March 24, 2025

Mr. Wayne Chouinard, PE
Assistant Town Engineer
Belmont Department of Public Works
19 Moore Street, Homer Building
Belmont, MA 02478

Re: McLean Hospital Child and Adolescent Center (Zone 4)
Response to Comments – Stormwater and Site Engineering

GASOLINE AND SAND SEPARATOR

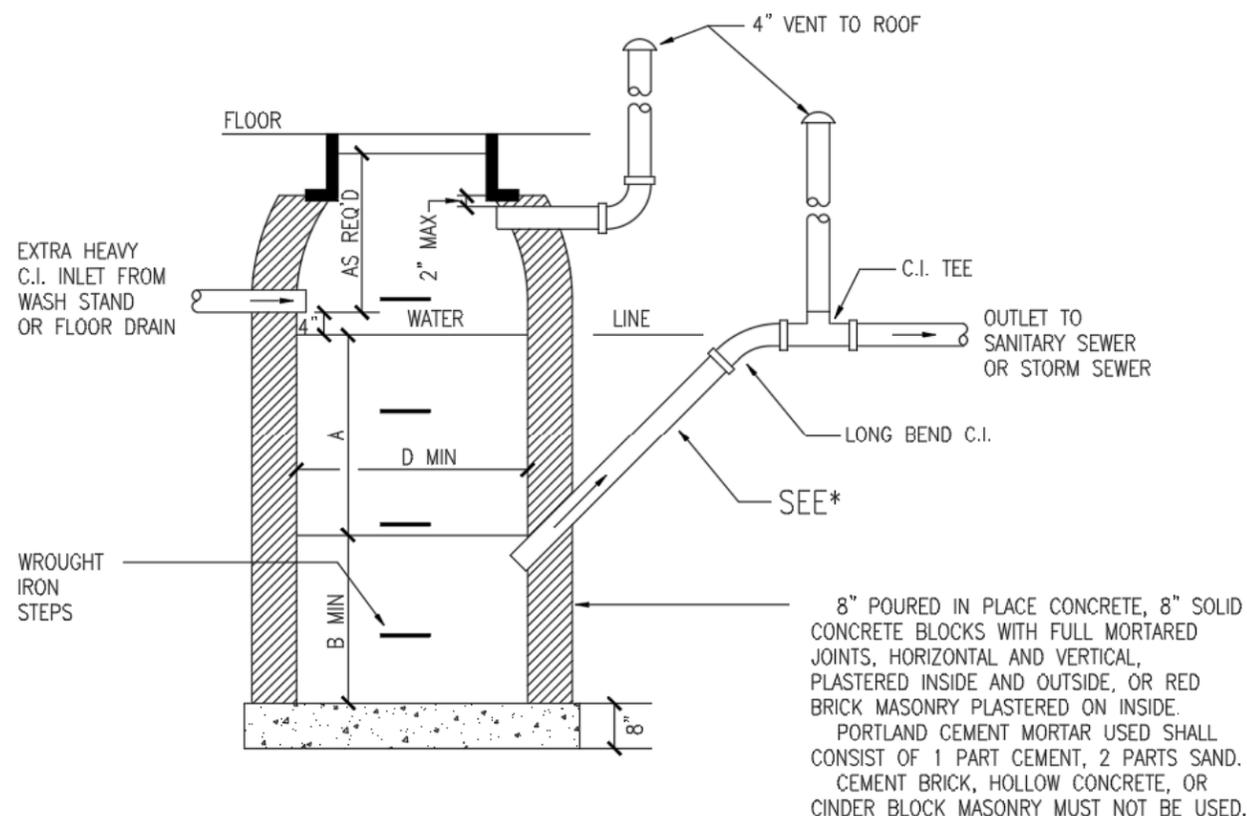
9. *Provide layout and details for the oil/gas separator unit required in the Parking Structure.*

Response: The location of the oil/gas separators associated with the garage interior floor drains (to sanitary sewer) will be at SMH 310. A call-out will be added to C401. The oil/gas separator for the garage roof discharge (to stormwater) will be added to C401 upstream of DMH 104. Whereas oil/gas separators fall within the scope of the plumbing code, these structures will be carried on the Project's plumbing drawings. To aid this comment response, a detail for the proposed oil/gas separator units meeting the requirements of the MA Plumbing Code has been included here as an attachment to this letter.
